MONTGOMERY COUNTY HISTORIC PRESERVATION COMMISSION
STAFF REPORT

Address:	6812 Connecticut Avenue, Chevy Chase	Meeting Date:	9/20/2023
Resource:	Master Plan Historic Site Eiker House M: 35/126	Report Date:	9/13/2023
Applicant:	Lisa Nelson	Public Notice:	9/6/2023
Review:	HAWP	Tax Credit:	No
Permit Number:	1038446	Staff:	John Liebertz
PROPOSAL: Fenestration alteration.

Figure 2: View of the façade of 6812 Connecticut Avenue, 2023.
Source: Montgomery Planning.

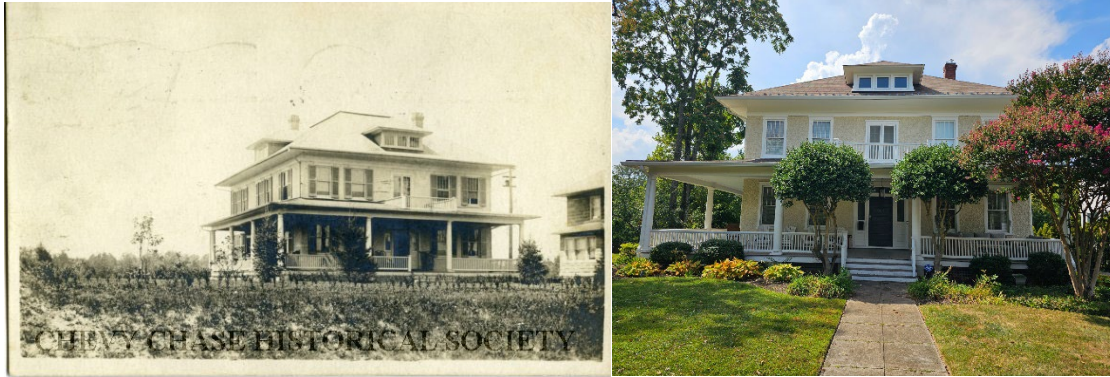
The subject property is an individually listed Master Plan Historic Site. The Colonial Revival house was constructed ca. 1908. The house has retained its character defining form, design, and materials (*Figure 2*). There are no relevant Historic Area Work Permits approved by the Historic Preservation Commission.

EXISTING &
 PROPOSED REAR
 ELEVATION

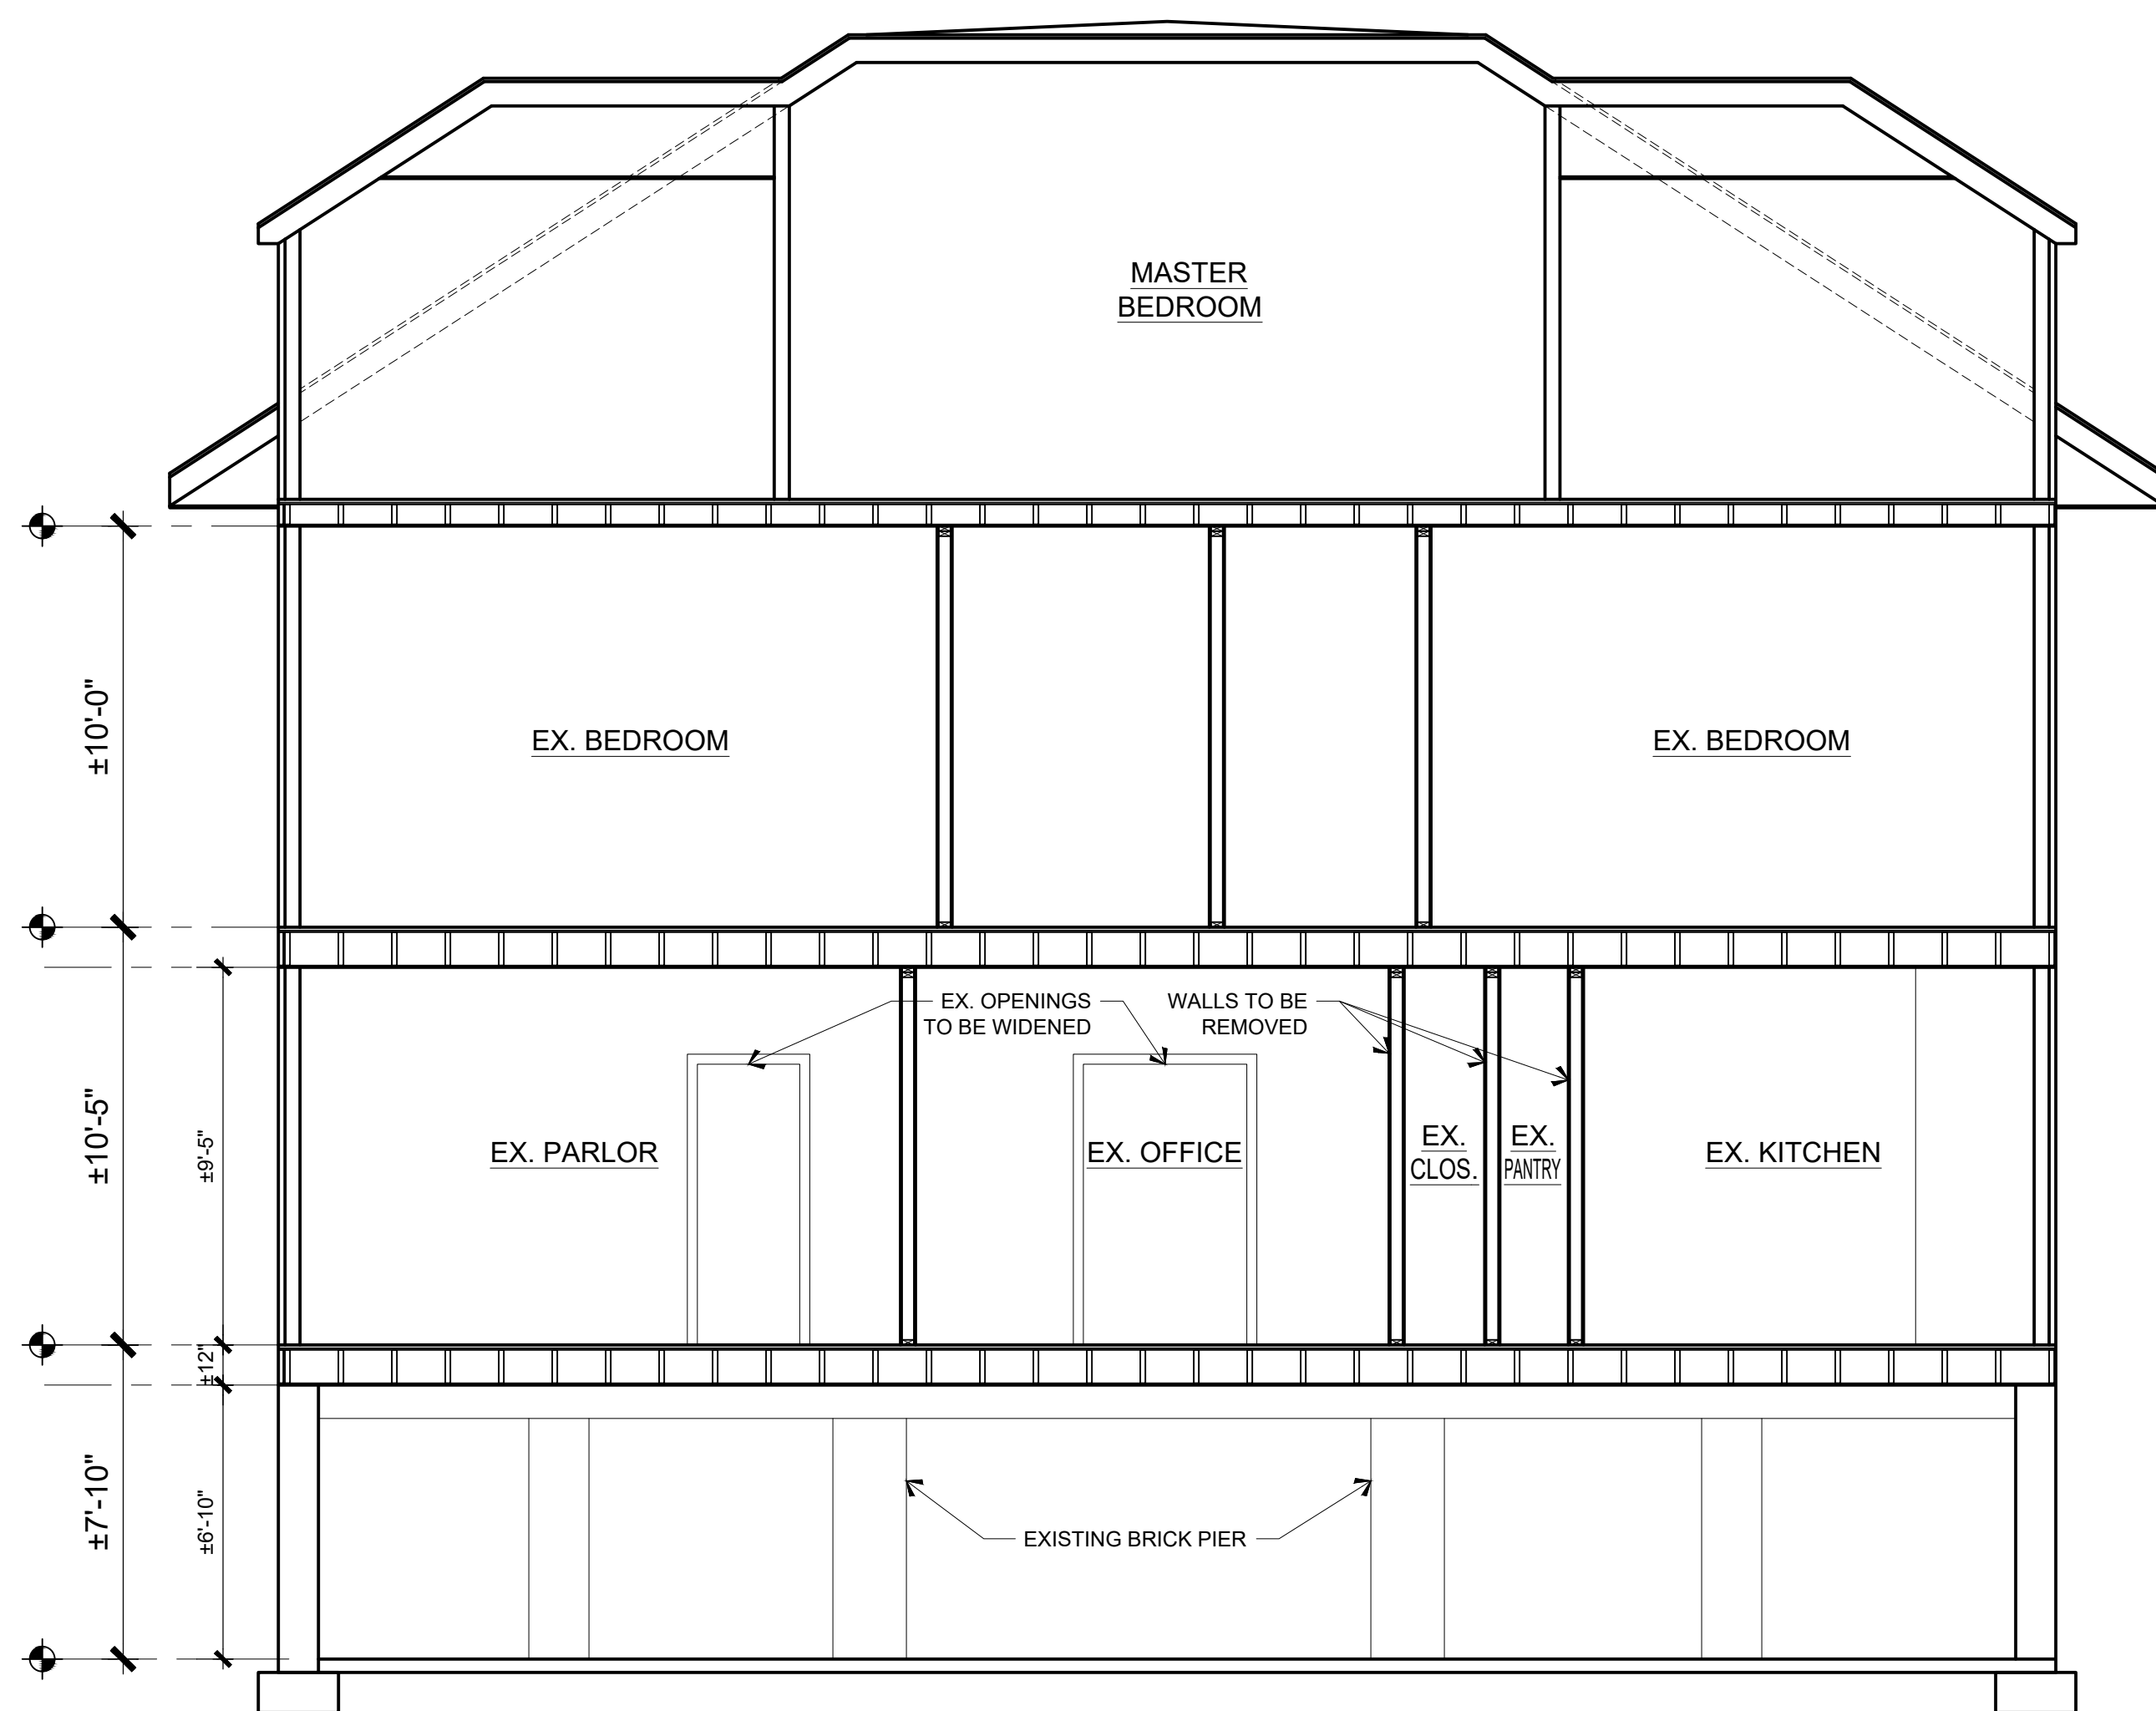
Staff noticed that the submitted plan set includes the removal/infill of a historic, four-light, wood window and installation of French doors with a balustrade (safety rail) on the rear elevation. This work is not included in the written scope of work. In addition, the existing elevation fails to account for the presence of the historic window (*Figure 4*).

While staff did not formally consider this proposal as its outside of the applicant’s submitted scope of work, staff would not support the installation of the French door. The use of such doors absent a porch/deck is incompatible with the Colonial Revival design of the Master Plan Historic Site. If the applicant chooses to pursue the proposal in a future HAWP, staff recommends consideration of alternative design solutions such as double-hung windows or the installation of doors with an associated porch/deck.

Figure 4: View of the rear elevation of 6812 Connecticut Avenue (left), the existing rear elevation as shown in the application (middle), and the proposed rear elevation (right) as shown in the application. Please note the missing four-light window (circled red) on the existing elevation and the proposed French doors (blue arrow).

1. The approval excludes the infill of the historic window on the rear elevation and installation of the French door.
2. The applicant shall update the existing drawing to show the missing historic window on the rear elevation.
